DATE: January 6, 1982
REVISION DATE: March 22, 1983
BULLETIN NO: II:26
PRODUCT: 26-4001/2 Model II
SUBASSEMBLY: AXX-0501 Z-80 CPU board (REV A/B/C)

PURPOSE: To outline enhanced DMA modification procedure.

Figure 1

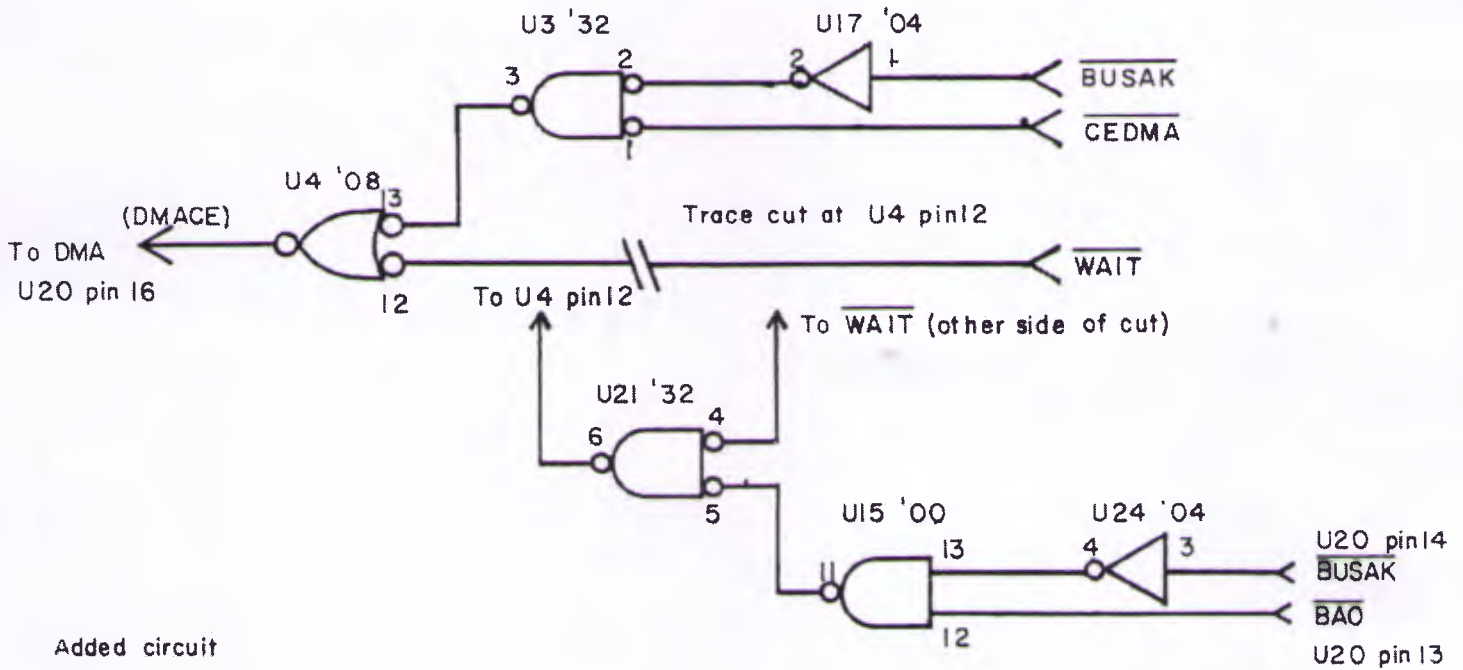
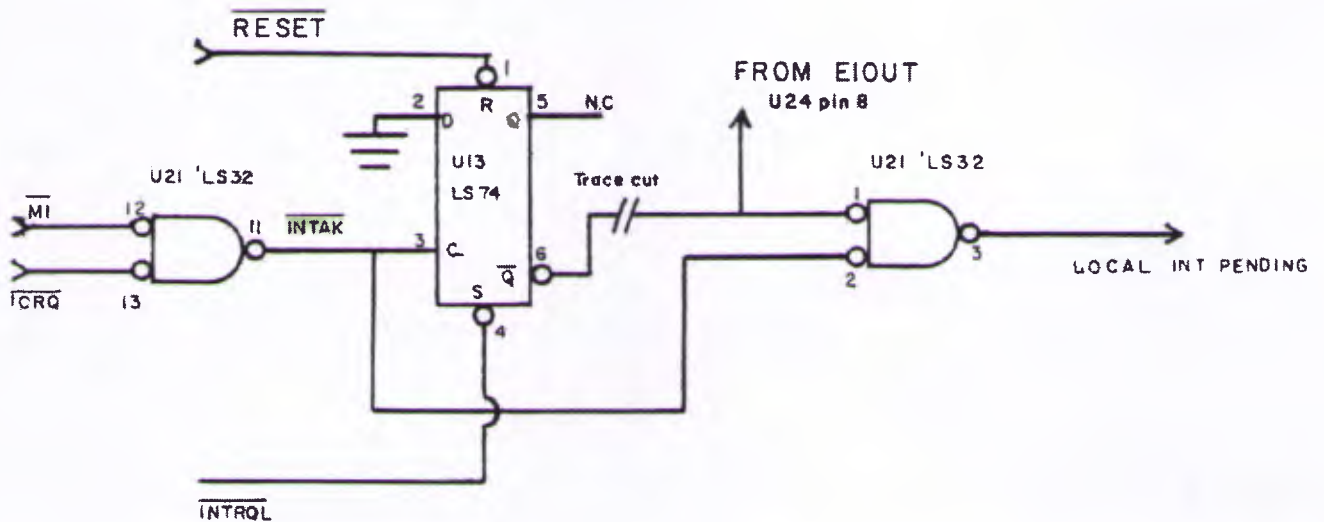
DISCUSSION: This modification is the same as the Hard Disk modification except it does not include anything unique to the Hard Disk such as the Boot ROM. Rev A, B, and C boards are the ONLY CPU boards to which this modification applies. DO NOT perform this modification on Rev D and later boards as they have this modification incorporated into their design. Refer to Figures 1 and 2 for schematic changes affected by this modification.

2 CUTS:

U4 pin 12 (cut right at the chip)
U13 pin 6 to U21 pin 1

7 JUMPERS:

U21 pin 1 to U24 pin 8
U4 pin 12 to U21 pin 6
U21 pin 4 to WAIT* (the first feedthru after the cut at U4 pin 12)
U21 pin 5 to U15 pin 11
U15 pin 12 to U20 pin 13
U15 pin 13 to U24 pin 4
U24 pin 3 to U20 pin 14
